CBD AND SOUTH EAST LIGHT RAIL PROJECT
STATE SIGNIFICANT INFRASTRUCTURE APPROVAL (SSI-6042)

MODIFICATION REPORT –
SSI-6042 MOD 4
Stop changes – High Street, Randwick

NOVEMBER 2015

Figure 3.2 Plan of the proposed location for the revised Randwick terminus stop arrangement

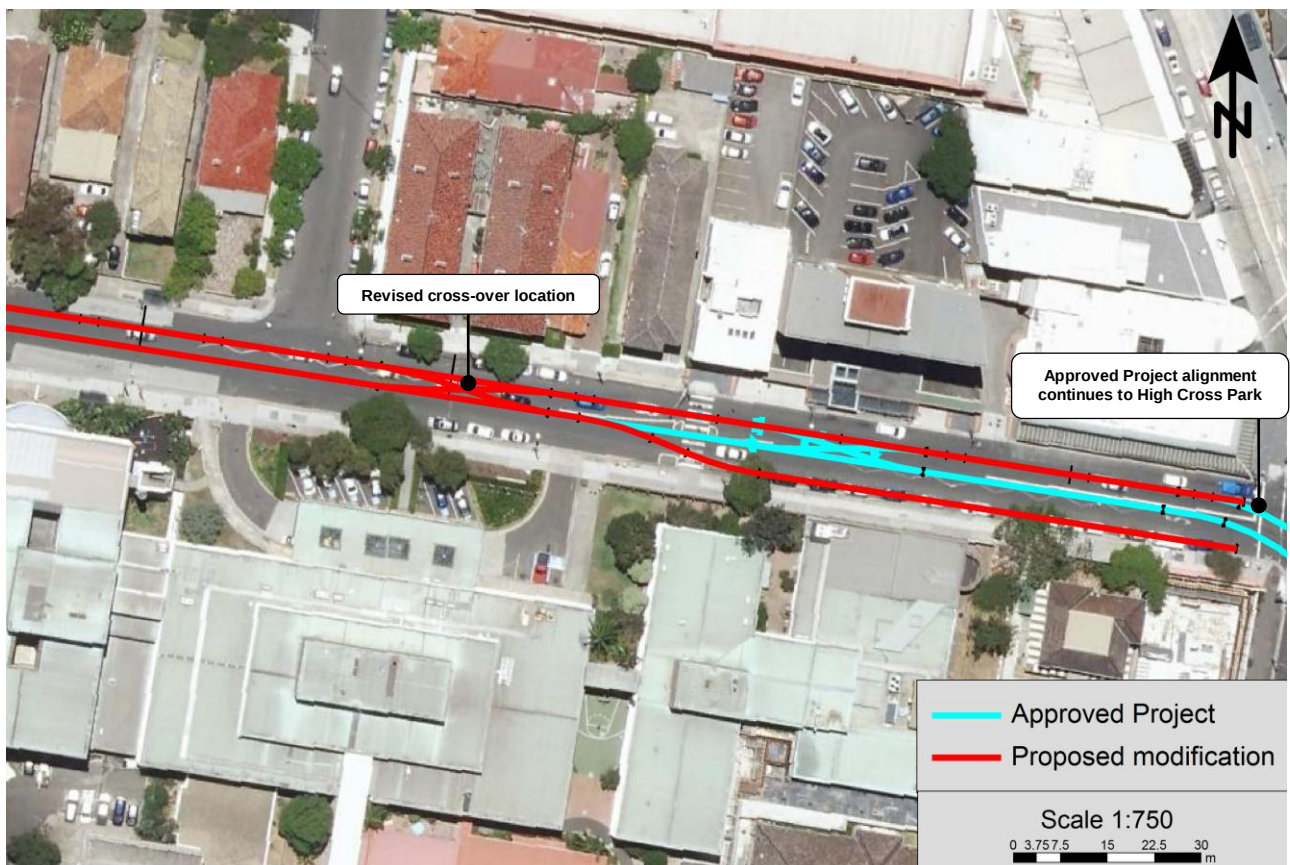
The revised design of the Randwick terminus stop would relocate the stop to High Street, west of the intersection of High Street and Avoca Street. The modified location for the stop would provide an approximately 67 metre long, 4.2 metre wide island platform with a weather protection shelter towards the eastern end of the platform. Revised pedestrian crossings would be provided at both the eastern and western ends of the platform.

A single, eastbound traffic lane for general traffic on High Street would be maintained to the north of the revised stop location between Clara Street and Avoca Street. The existing westbound traffic lane would be removed at this location. The east and westbound traffic lanes would be retained between Clara Street and Botany Street.

The existing pedestrian paths along the northern and southern sides of High Street would be retained as part of the proposed modification. The changes as part of the modification would also result in a slightly revised vehicle access to the Prince of Wales Hospital, including the provision of a revised public drop off zone for the Prince of Wales Hospital on the southern side of High Street and. This would be consistent with the Minister's Conditions of Approval (MCoA) B42 which requires that, as part of the project, a revised taxi rank and passenger drop off area at the entry to the Hospital be provided (refer to Figure 3.2).

Figure 3.5 Plan of the revised UNSW High Street stop arrangement

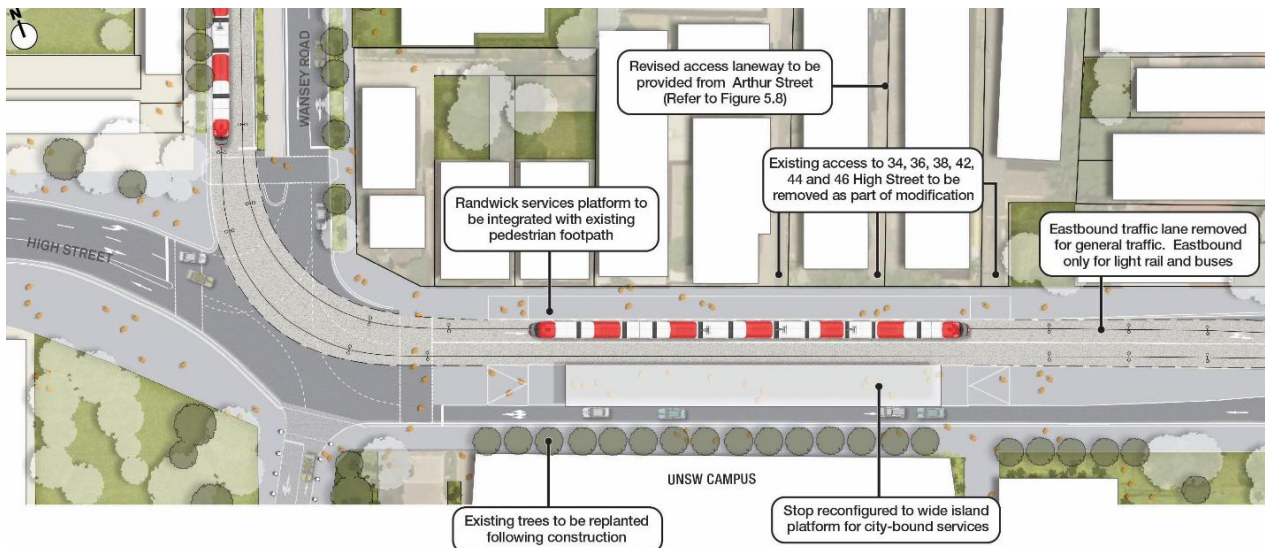
The modification to the UNSW High Street stop would change the approved stop from a single island platform to two separate platforms. The northern platform would be integrated as part of the existing pedestrian footpath with a combined width of approximately 4.5 metres. The southern platform would consist of a platform approximately 6 metres wide with a fenced barrier between the southern edge of the platform and the westbound traffic lane along High Street. The stop would be located approximately 5 to 6 metres north of the previously approved location.

A canopy shelter would be provided on the southern platform for shade and weather protection. The northern platform would not be provided with a canopy shelter due to the primarily disembarking function of this platform. Passengers would cross High Street at the signalised crossings at either Wansey Road or Botany Street.

The modification would result in the removal of the eastbound traffic lane along High Street between Wansey Road and Botany Street. For this section of the alignment, the eastbound light rail tracks would become a bus and light rail-only shared zone (refer to Figure 3.7). Existing eastbound general traffic would be required to utilise an alternative route along Arthur Street. The existing westbound traffic lane would be retained for general traffic, however this lane would be realigned by approximately 4 to 5 metres to the south to accommodate the stop platform. A new pedestrian footpath would also be provided at this location on land currently owned by UNSW.

Figure 3.8 Plan of the proposed access lane arrangement from Arthur Street

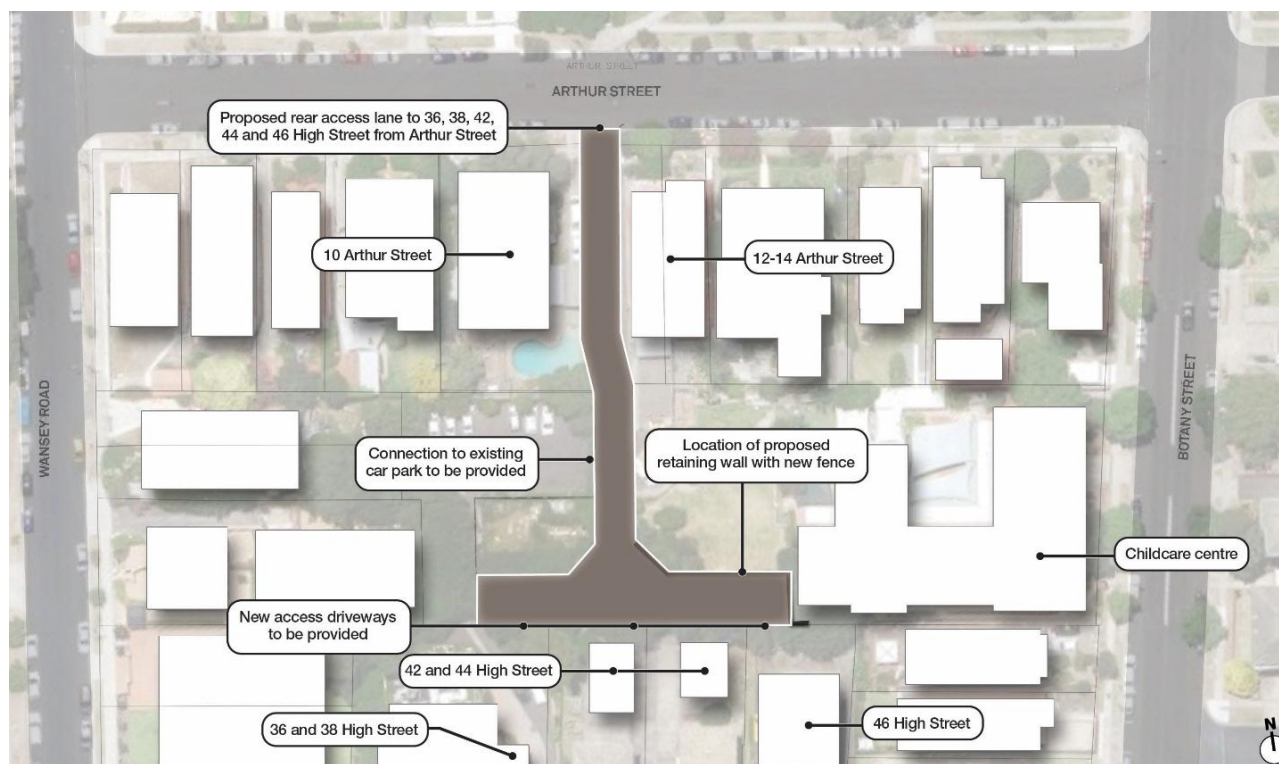
In order to maintain vehicle access to these properties, it is proposed that a new access lane be provided from the rear of these properties to Arthur Street to provide a reconfigured driveway access to all four affected properties. The cul-de-sac would be suitable to meet access requirements for a range of vehicles, including garbage collection and removalist vehicles, to turn around without the need to reverse along the entire length of new lane.

Due to ground level differences, a retaining wall between approximately 0.1 metres and 1.5 metres high would be required towards the north east side of the hammer head shaped road area.

New fencing would be provided along the boundary of the access lane area with appropriate lighting to maintain a suitable level of safety. Some minor vegetation clearance on Arthur Street would be required to maintain suitable sight distances along Arthur Street for vehicles accessing Arthur Street from the new lane.

Figure 3.9 Proposed changes to traffic flow within the Randwick Precinct

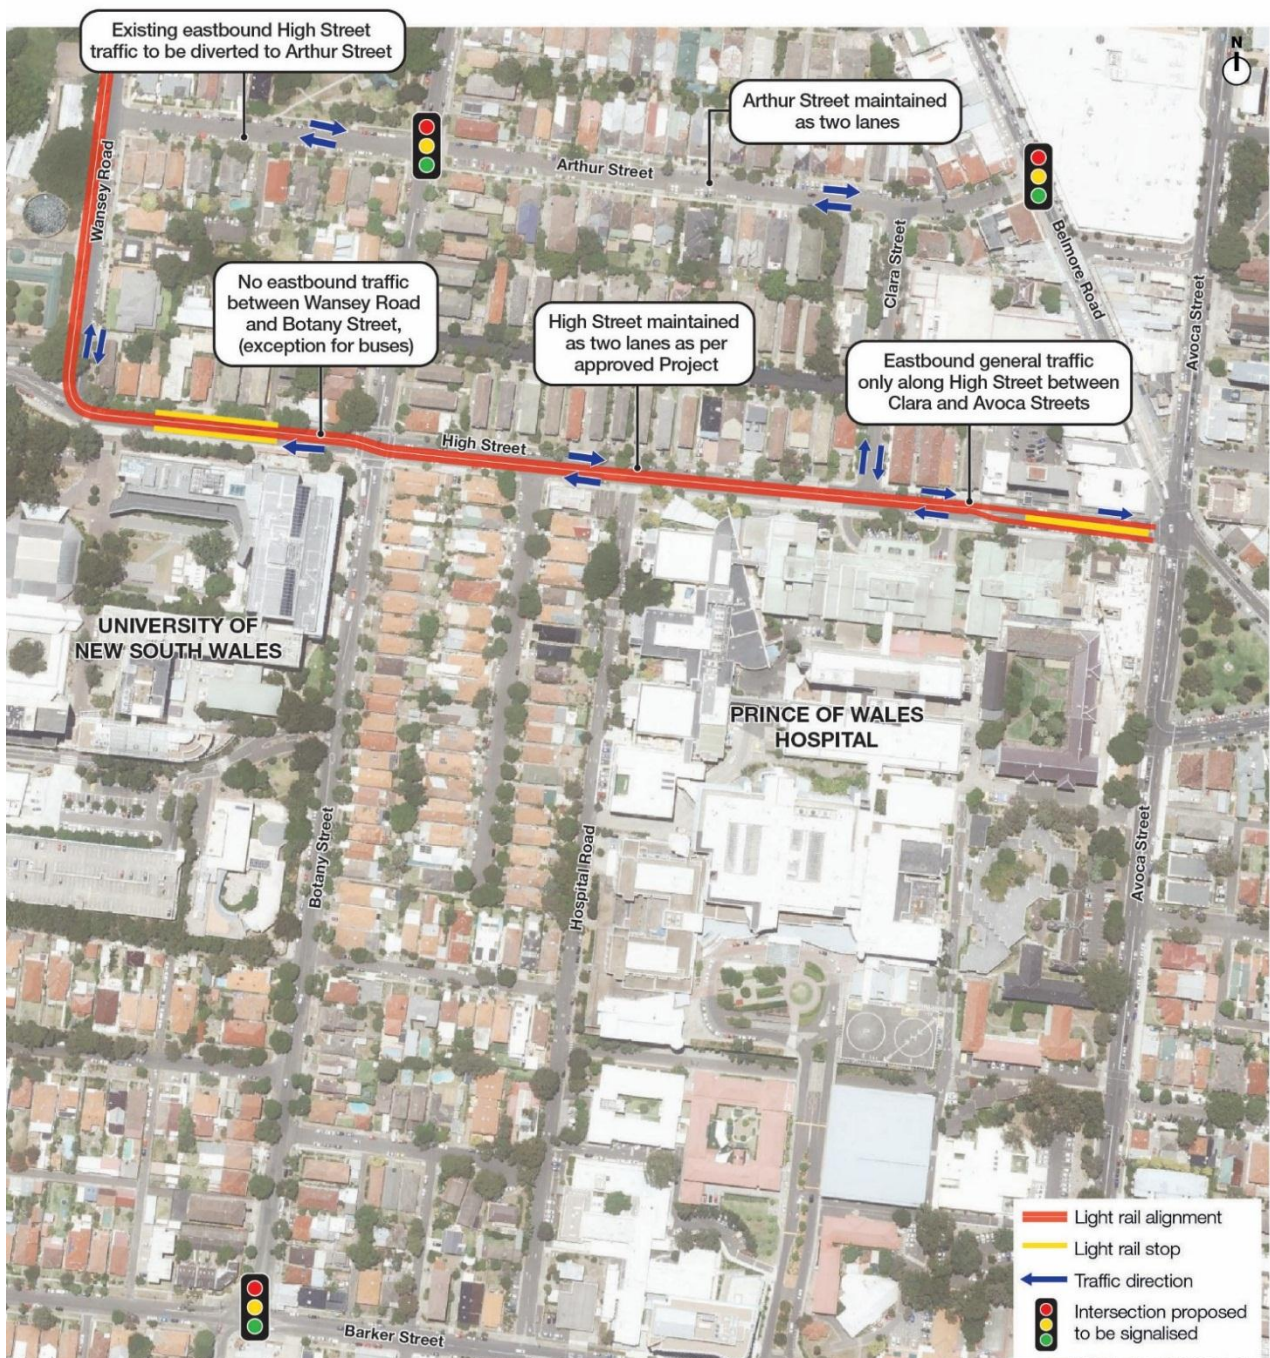
General traffic which currently travels along the sections of High Street, which would be removed for the modified design, would be required to travel along an alternative route in order to reach their destinations. With respect to the proposed changes at the Randwick terminus stop, it is anticipated that the majority of traffic would travel along either Alison Road, Arthur Street or Barker Street, depending on the trip origin and destination.

With respect to the proposed changes associated with the UNSW High Street stop, it is anticipated that most vehicles would travel along Wansey Road and Arthur Street, and either continue along either Arthur Street or turn into Botany Street, depending on their destination. The revised traffic flows that would occur as a result of the modification are shown in Figure 3.9.

Figure 3.11 Proposed reconfiguration of the Randwick terminus stop and interchange bus stop arrangements and proposed substation location (below ground)

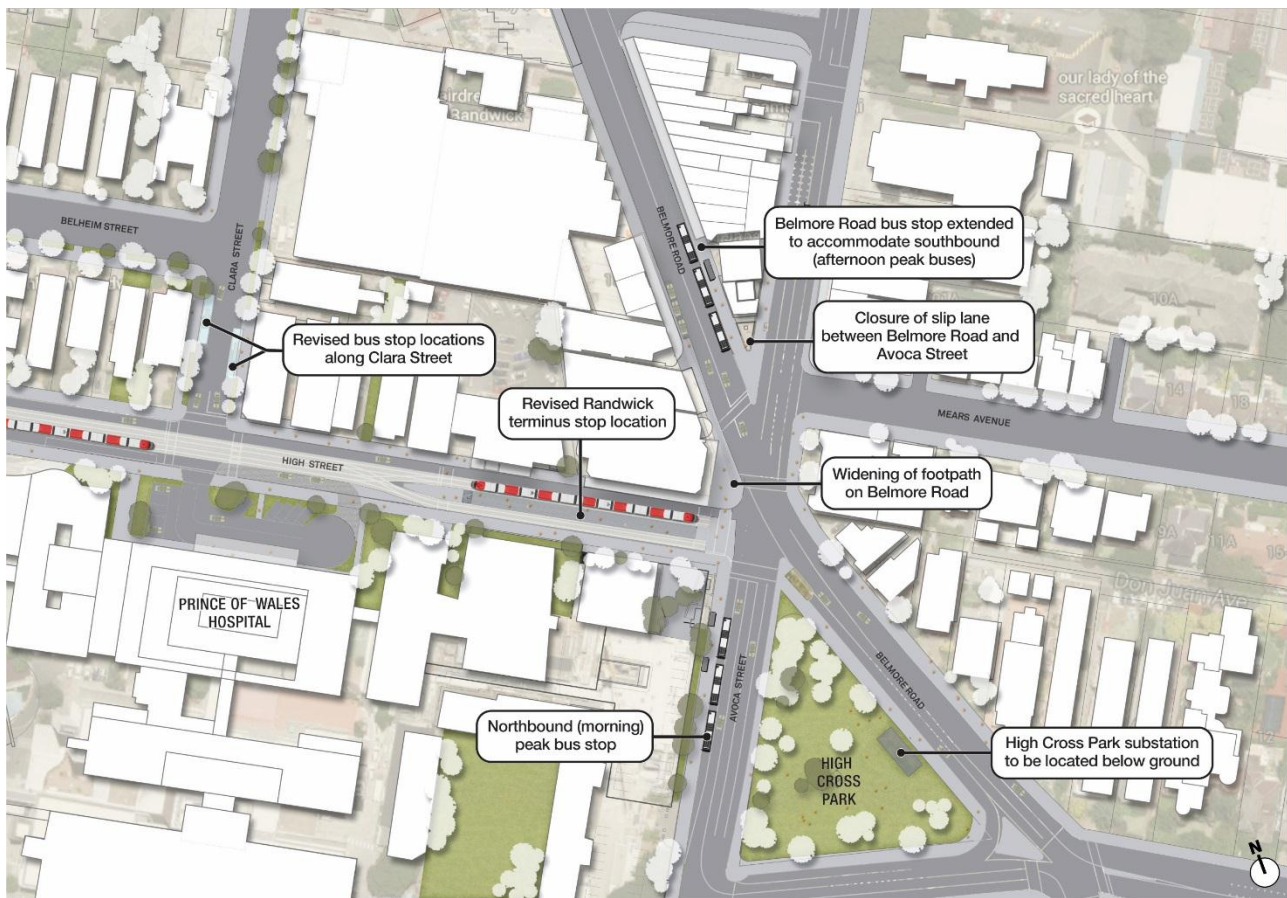
The existing westbound bus stop outside the Prince of Wales Hospital would be removed as part of the modified design due to the removal of the westbound lane along High Street. The stop would be relocated to Clara Street, near the intersection of Clara Street and High Street. This would result in the loss of approximately four short term parking spaces along this street. A new bus shelter would also be provided at this location.

A southbound bus stop currently exists at the intersection of Belmore Road and Avoca Street with capacity for up to two buses. The bus stop zone along Belmore Road at this location is proposed to be extended by approximately 20 metres to allow for up to two additional buses at this location in the afternoon peak period. The provision of the additional bus stop would result in the removal of approximately four short term parking spaces. An indicative arrangement of this stop is provided in Figure 3.11. As part of the revised bus stop arrangement, the awning coverage along Belmore Road would be extended to permit the afternoon bus stop to be located as close to the corner of Belmore and Avoca as possible (to be undertaken by Randwick City Council).

A new northbound morning bus stop zone on the western side of Avoca Street would also be provided as part of the changes associated with the modification. This would allow up to four buses to stop within the western-most lane along Avoca Street, to the south of High Street during the morning peak period. As a result of the proposed changes to bus stops along Belmore Road and Avoca Street, approved bus stops within High Cross Park along Avoca Street (southbound) and Cuthill Street (refer to Figure 2.1) would no longer be required. This would result in a reduced impact to High Cross Park, including the retention of approximately 33 trees and open space within the park and approximately 18 parking spaces adjacent to High Cross Park (on Belmore Road and Cuthill Street) which were previously identified to be removed under the approved project.

Figure 3.12 Existing High Cross Park construction compound layout (left) and revised construction compound layout (right)

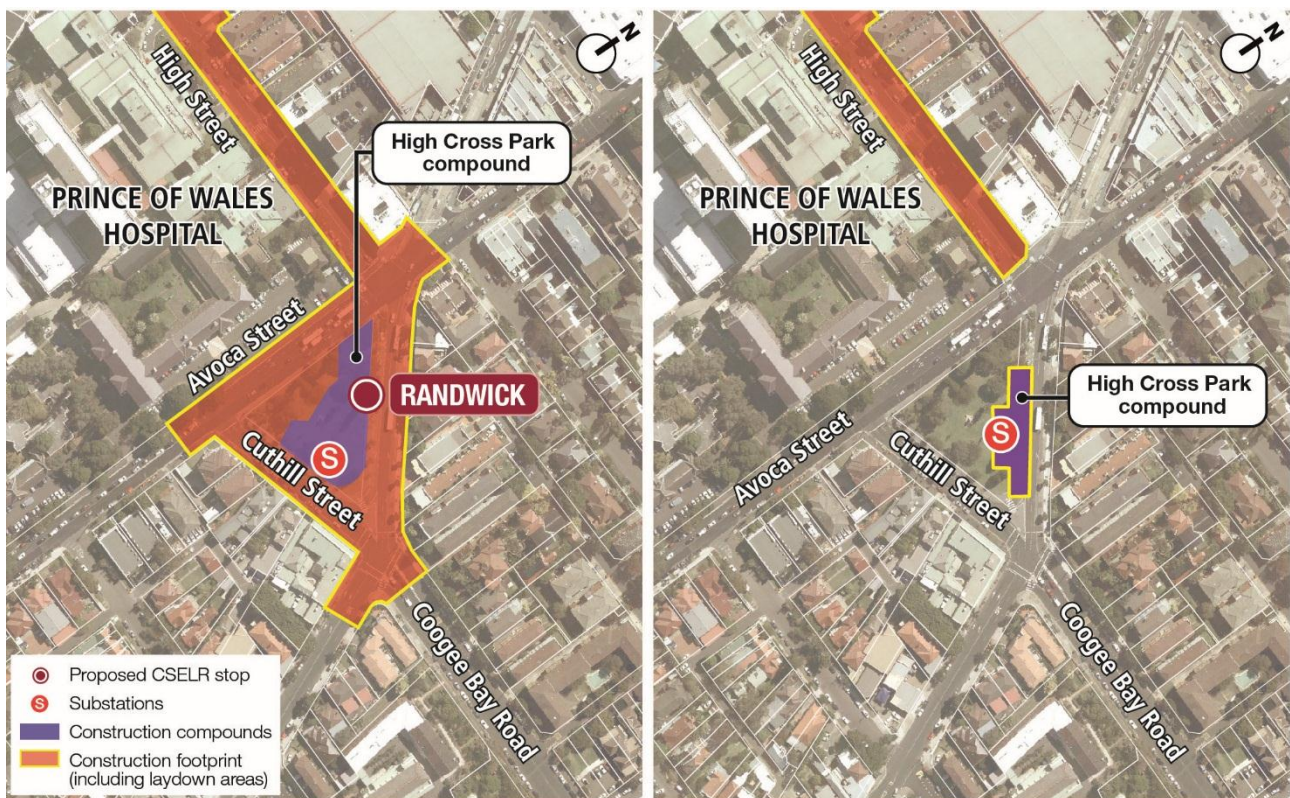
As a result of the relocation of the Randwick terminus, the construction compound in High Cross Park would be reconfigured to reduce the overall impact on High Cross Park. The reconfigured compound site would occupy the existing footpath, one lane of parking and one lane currently used for vehicle traffic on Belmore Road. The revised construction compound layout would be arranged to limit impacts to any trees within High Cross Park. An indicative arrangement of the revised construction compound layout is shown in Figure 3.12.
